STAFF RECOMMENDATION
1733 4th Avenue North
June 19, 2013

Application: New construction-addition
District: Salemtown Neighborhood Conservation Zoning Overlay
Council District: 19
Map and Parcel Number: 08205001500
Applicant: Ryan Stackhouse, Troy Stackhouse
Project Lead: Robin Zeigler, robin.zeigler@nashville.gov

<p>Description of Project: Applicants propose a two-story addition to a one and one-half story, hipped-roof, historic house.</p> <p>Recommendation Summary: Staff recommends approval with the conditions that all materials receive administrative approval and that if the mechanicals are relocated, that they be located beyond the midpoint of the house or at the rear. With these conditions, the project meets the design guidelines for an addition in the Salemtown Neighborhood Conservation Zoning Overlay.</p>	<p>Attachments A: Photographs B: Site Plan D: Elevations</p>
---	--

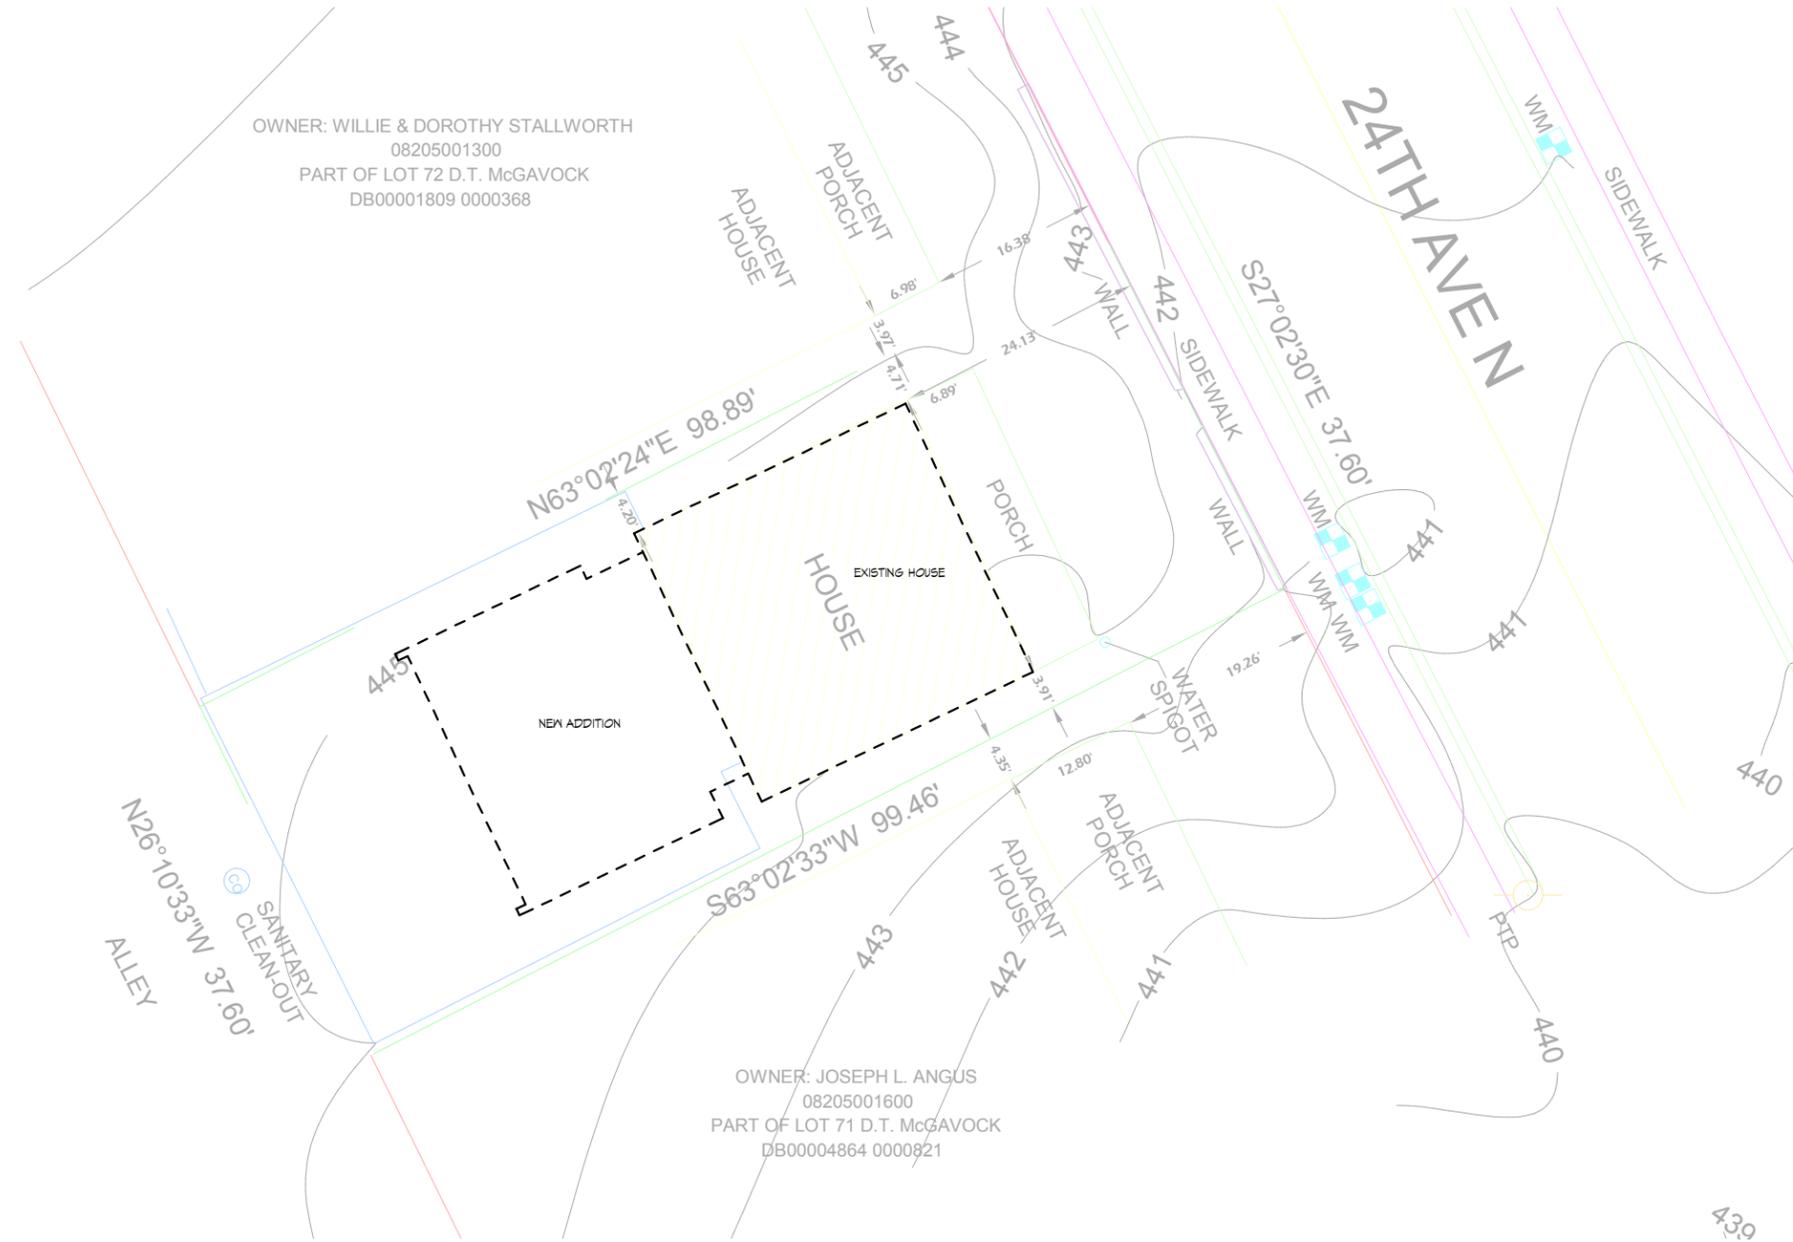
The front of the house will not be altered. Two existing windows on the sides and toward the rear of the building will be altered in size but retain existing proportions. Staff finds this alteration of the historic fabric to be appropriate since they are towards the back of the house, minimally visible, and will remain as openings.

Left side, rear window will match the size of the front/side window.

Right side, rear window will be shorter than existing.
